8-27-92

DECISION MADE BY DFL,  
FMH, CPB !!!

JOINT AT INTERMEDIATE BENT  
Scale: 3" = 1'-0"

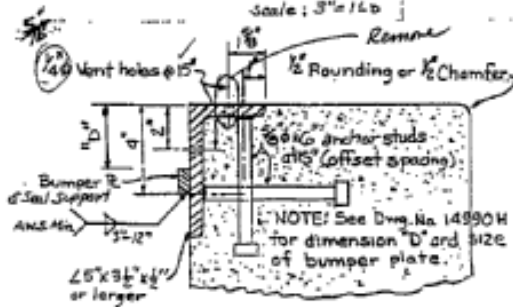
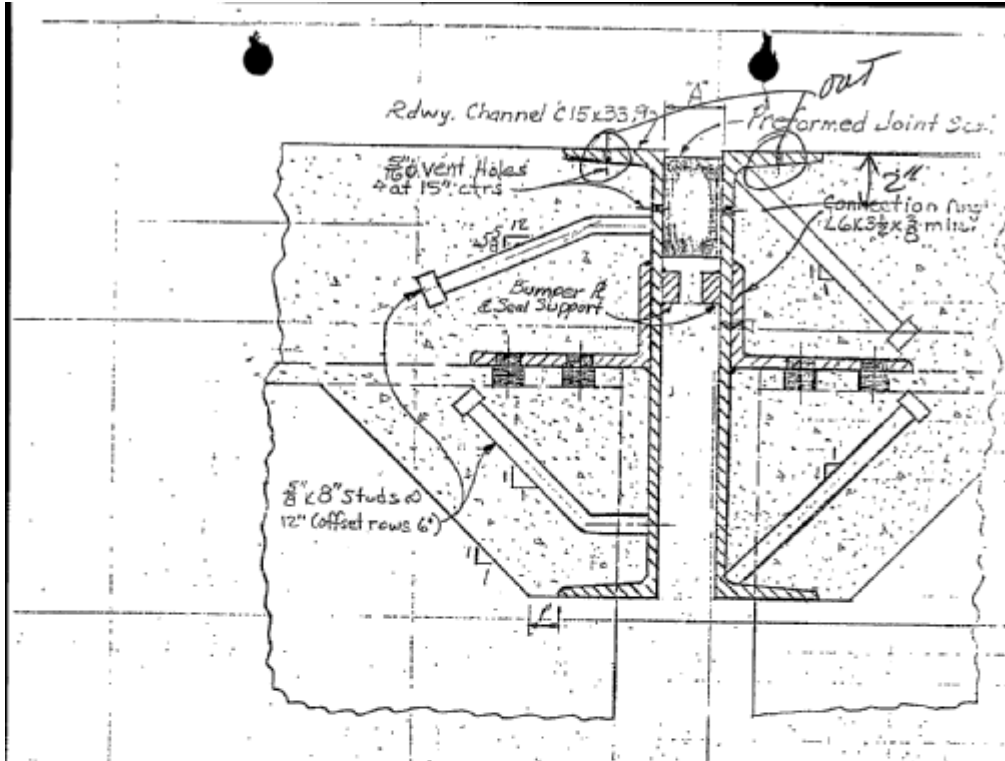
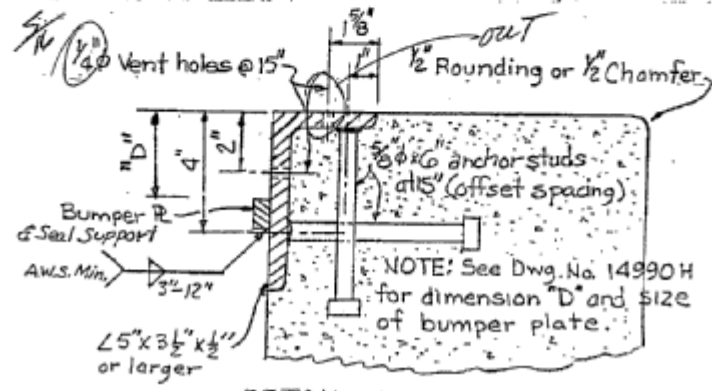
Use  $\frac{5}{8}$ "  $\phi$  Vent Hole @ 15"  
CTR. 2" below roadway  
Surface on Vertical face  
of angle and channel only.
